Expert Witness Statement of Joel Georgiou

**IN THE MATTER OF THE
FINGERBOARDS MINERAL SANDS
PROJECT EES**

**Prepared for Kalbar Operations Pty Ltd
February 2021**

**Depth to water table based on the
 Victorian Aquifer Framework**

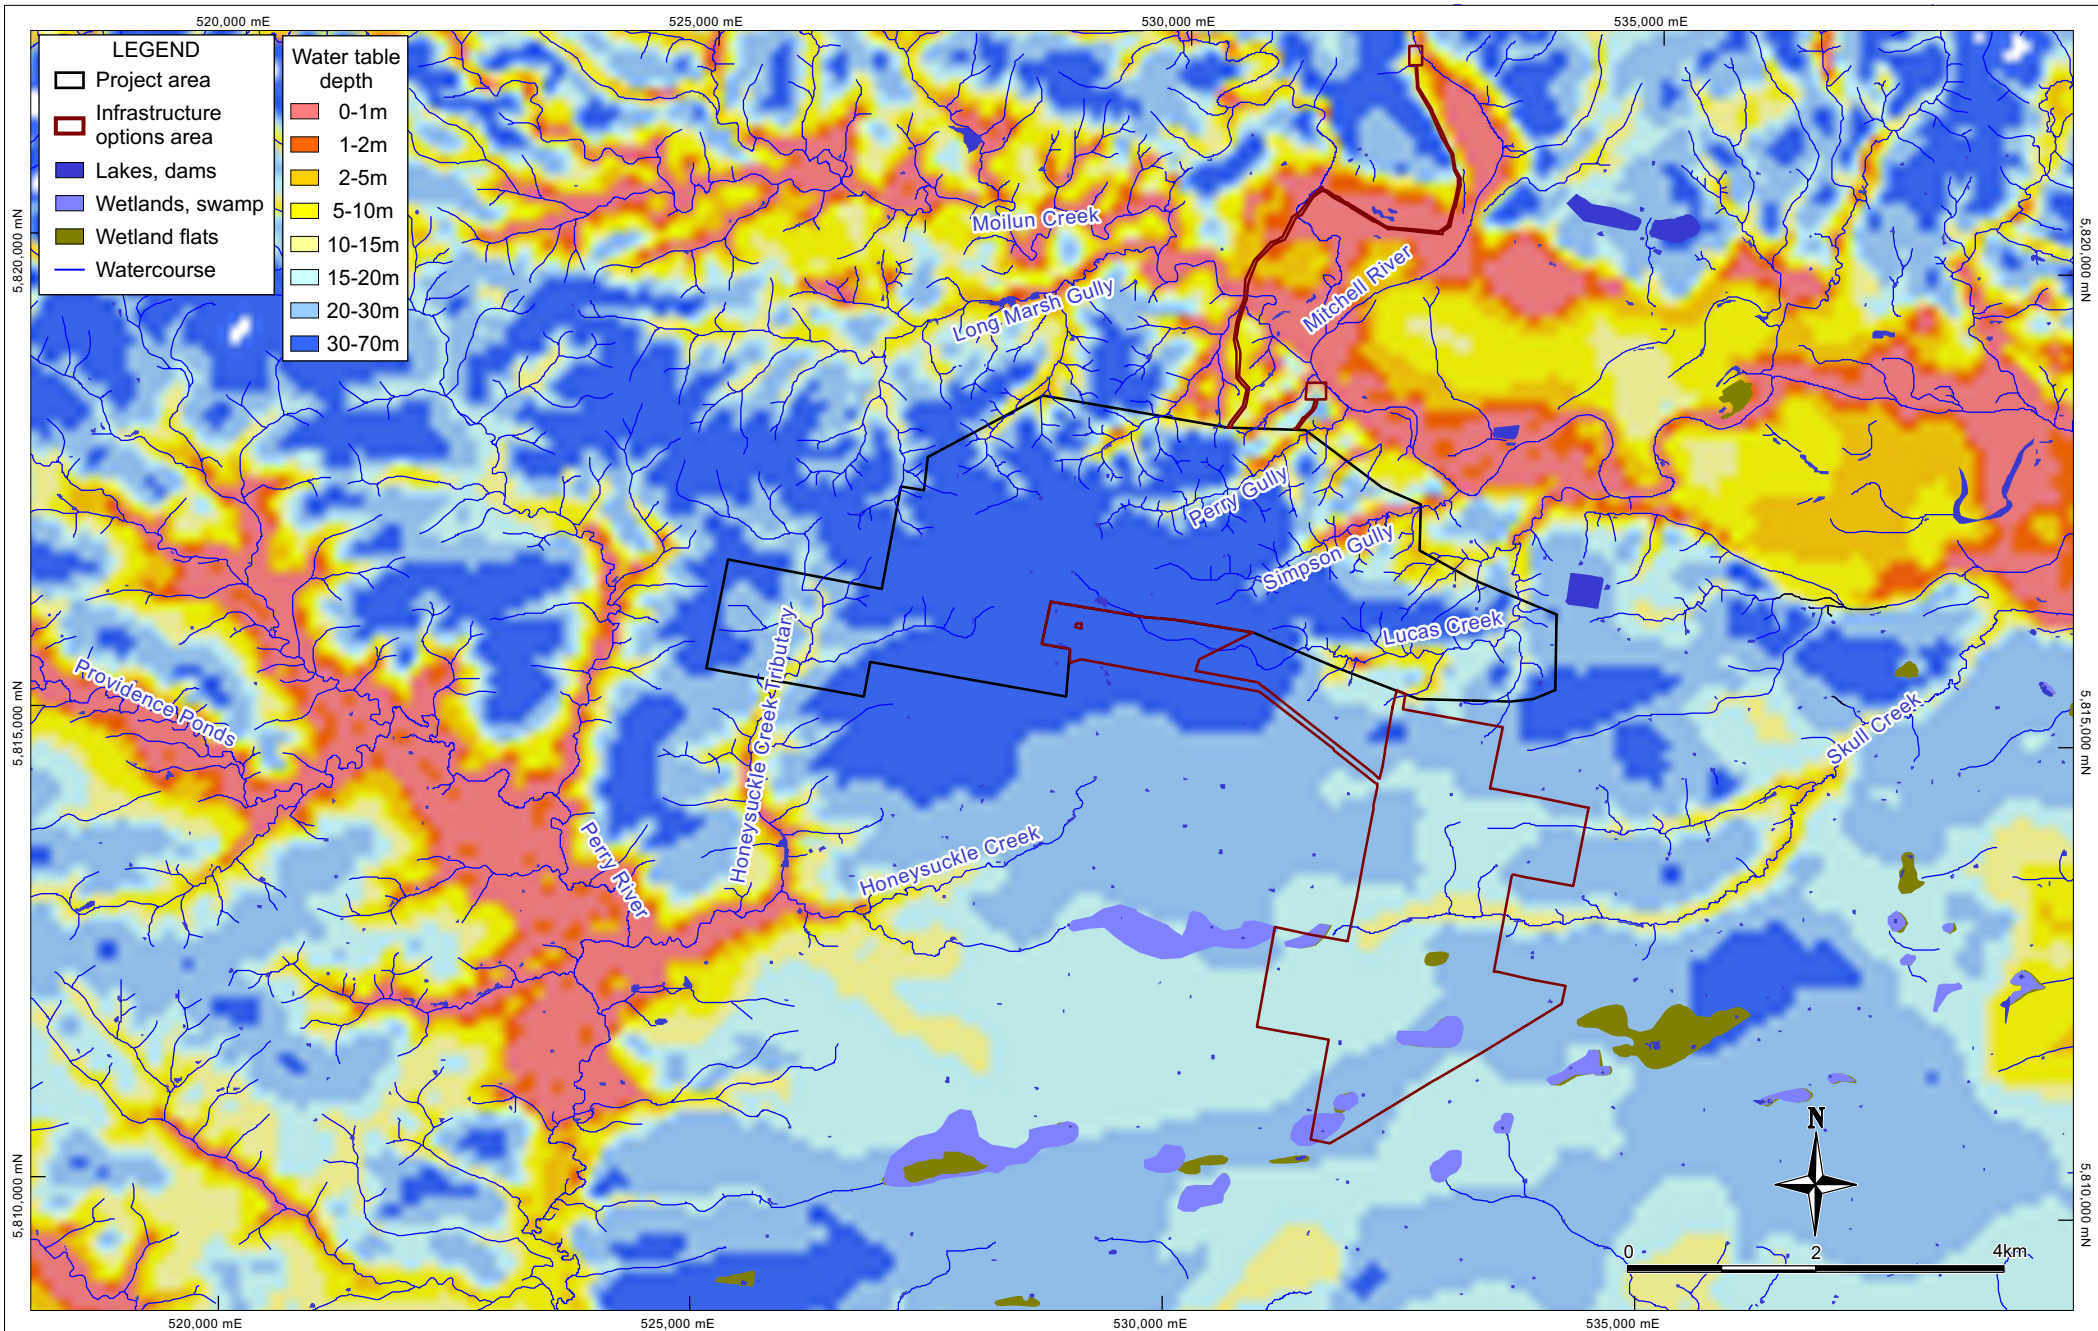
Although the data to date suggest that the chain of ponds and sections of the Perry River are likely supported by a perched system, this is not totally consistent with the VAF dataset shown in Figure 5.3. This figure shows the depth to the water table (hosted within the shallow aquifer system) and was created by subtracting the VAF water table contours from the topography. Shallow depth to water table is inferred throughout the Perry River catchment, which contradicts site-based studies (ie resource drilling and GDE studies undertaken by EHP) and the numerical groundwater model (EES Appendix A006/B).

Referring to Figure 5.3, the depth to water table map based on the VAF datasets suggests the potential for a few spring locations to occur due to shallow water table areas including:

In conclusion based on the data assessed, the conceptualisation supports that perching is a localised phenomenon and clay layering within the Coongulmerang Formation, which controls the development of perched groundwater lenses, is likely to be sporadic. Any springs that support dams are likely to be supported by these local and finite systems, and not supported by deeper artesian groundwater.

Figure 5.6 IESC guide for identifying, assessing, and developing GDE management plans

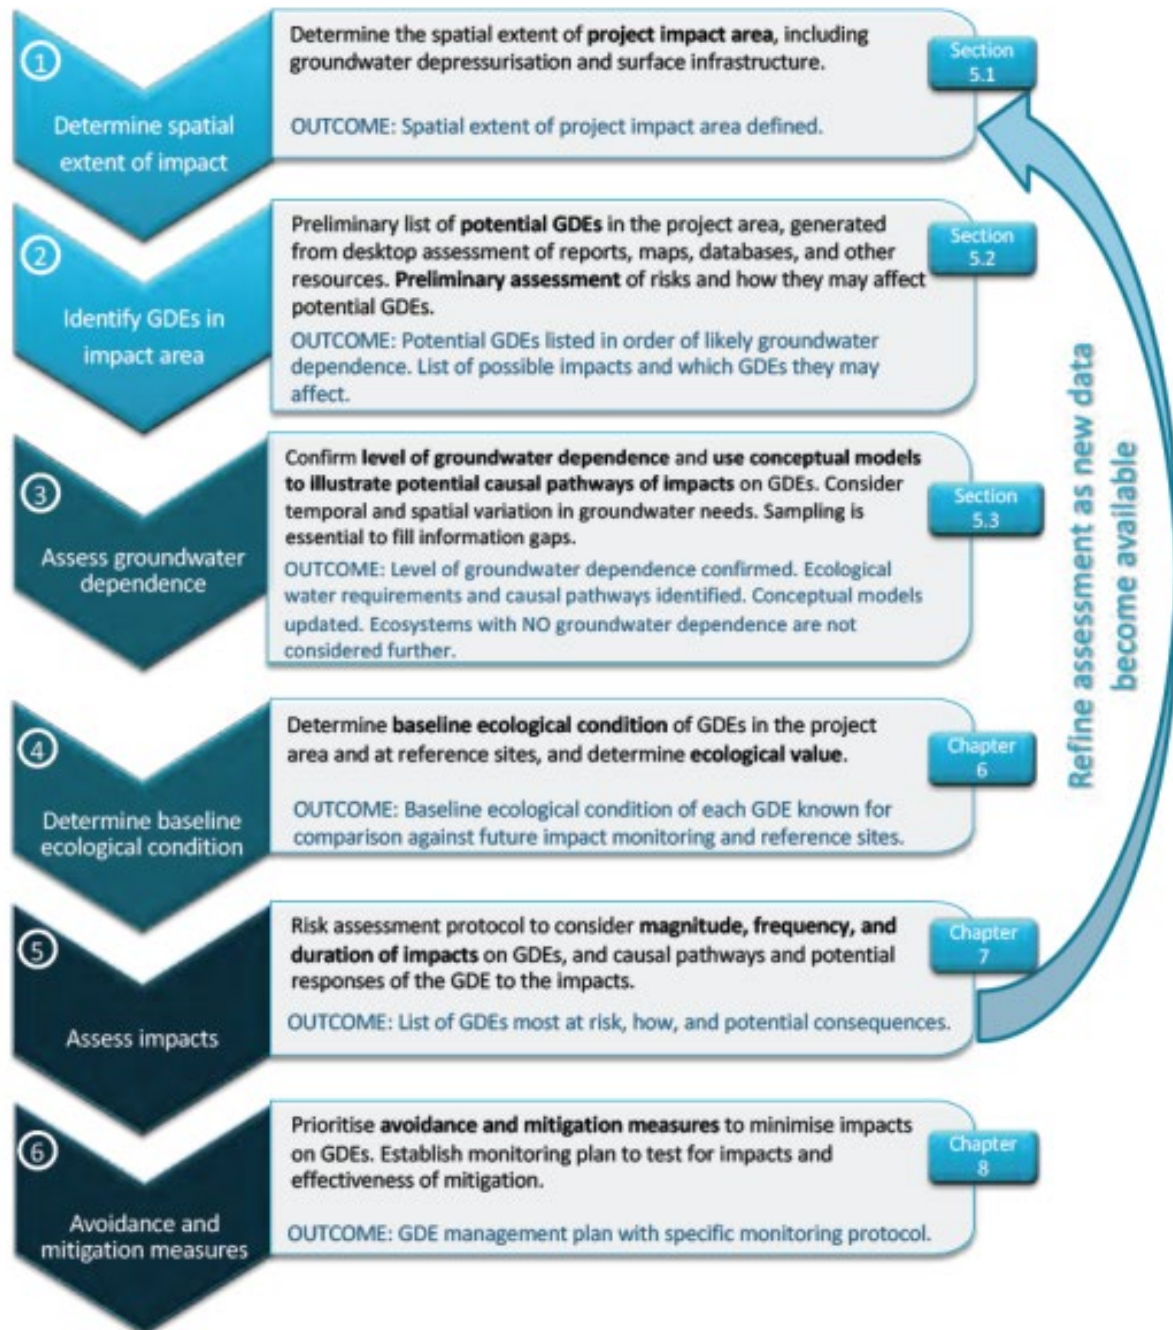
GDEs associated with chain of ponds and spring fed dams (initially raised by the TRG in section 5.3.3, and also with landowner submissions, Section 5.4.4) were not identified during site surveys. Furthermore, as discussed in Section 5.3.2, although data to date suggest that the chain of ponds and sections of the Perry River are likely supported by a perched system, this is not totally consistent with the VAF dataset shown in Figure 5.3.

To address this inconsistency and to establish a comprehensive baseline of GDEs for the purpose of developing mitigation and management plans as recommended in Section 5.4.2v, I recommend a comprehensive GDE survey and assessment be undertaken for those sites which could be potentially impacted by mining activities, which should consider the observations made by the government, local landowners, and the general community. The framework should follow the guidelines outlined within the IESC Information Guidelines Explanatory Note: Assessing groundwater-dependent ecosystems (Doody et al. 2019), provided in Figure 5.6.

Figure 5.7 Pre-mining groundwater contours based on the VAF and EMM's interpretation (mAHD)

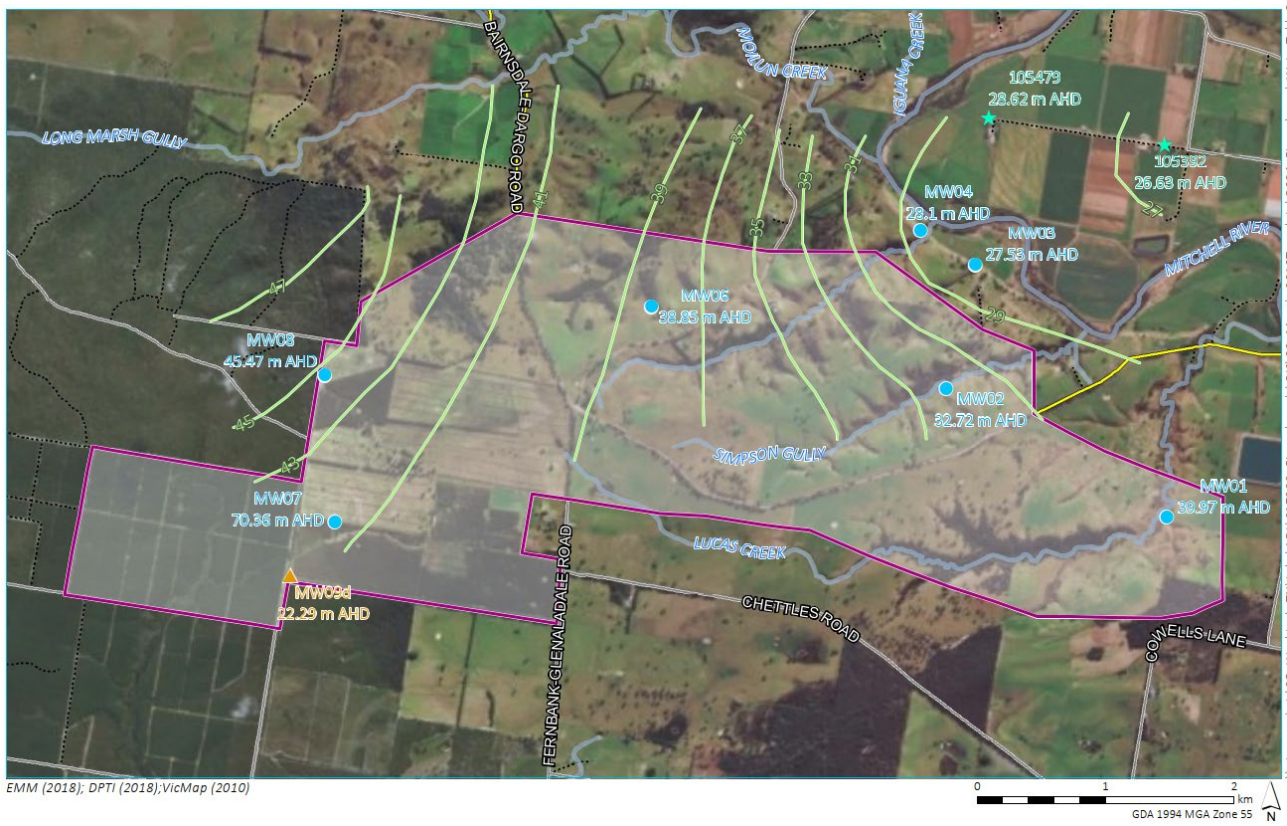
- SLR, on behalf of Council (submission 716), questioned the statement that groundwater does not move to the west towards the Perry River catchment. They proposed an alternative interpretation of the data presented, ie that groundwater beneath the east half of site flows toward Mitchell River, and beneath the west half of the site flows toward Perry River. They suggest this possibility does not appear to have been considered in the model conceptualisation and risk assessment; and
- SLR suggests the installation of additional bores west and north of the site to better delineate groundwater flow directions.

In my groundwater modelling report (EES Appendix A006/B) I provided a slightly different interpretation of the same dataset used by Coffey, but also considered the groundwater contours from the VAF, which assumes groundwater recharge occurs in the highlands and regional flow originates from the north-west (see Figure 5.7). The pre-mining modelled groundwater contours for the Coongulmerang formation (water table aquifer) are shown in Figure 5.8. This shows consistency with the interpretations shown in Figure 5.7, with groundwater flow, from a local perspective, originating from the north-west and flowing towards the east with some local perturbation towards the Mitchell River floodplain, being the main discharge area locally.

I acknowledge that additional monitoring bores as recommended by SLR would help confirm this and would also provide Kalbar with additional bores away from the site which could be used as control sites, which remain unimpacted from mining activities. However, based on the available data I am confident in my estimates of groundwater flows as presented in Figures 5.7 and 5.8.

I conclude that groundwater contours and flow directions at the Fingerboards site are well understood at a level of detail sufficient to inform the EES.
